**NUMBER:** 14-002-13 REV. A

**GROUP:** Fuel System

**SUBJECT:**

Fuel Spit Back During Refueling Due To Inlet Check Valve (X48 Lifetime Warranty Extension)

**Fig. 1 Fuel Filler Tube**

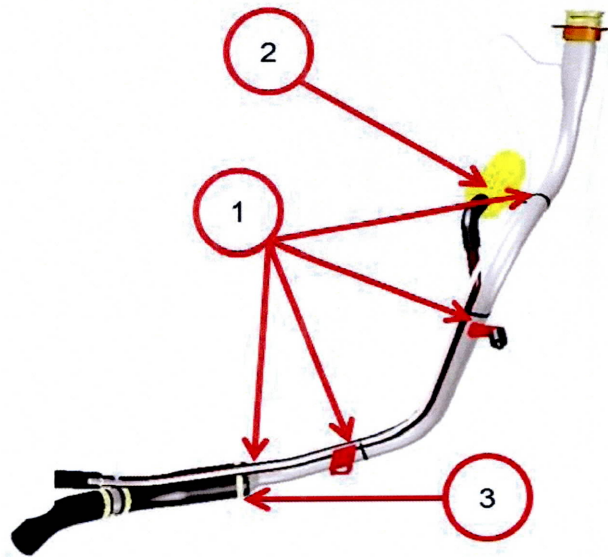
**THIS BULLETIN SUPERSEDES SERVICE BULLETIN 14-002-13, DATED JANUARY 30, 2013, WHICH SHOULD BE REMOVED FROM YOUR FILES. ALL REVISIONS ARE HIGHLIGHTED WITH **\*\*ASTERISKS\*\*** AND INCLUDE THE ADDITIONAL STEP TO REMOVE AND DISCARD THE EVAPORATIVE FILTER AND TUBE FROM THE FUEL FILLER HOSE.**

1. **\*\*The new fuel filler tube (p/n CNNZX390AA) has an evaporative emission hose and filter assembly attached to the filler neck (Fig. 1) that will not be used in this repair. Cut the four tie straps that secure the evaporative filter and hose to the new fuel filler tube. Remove and discard the evaporative filter and hose.\*\***
2. On new fuel filler tube verify and write down existing torque (Fig. 1).
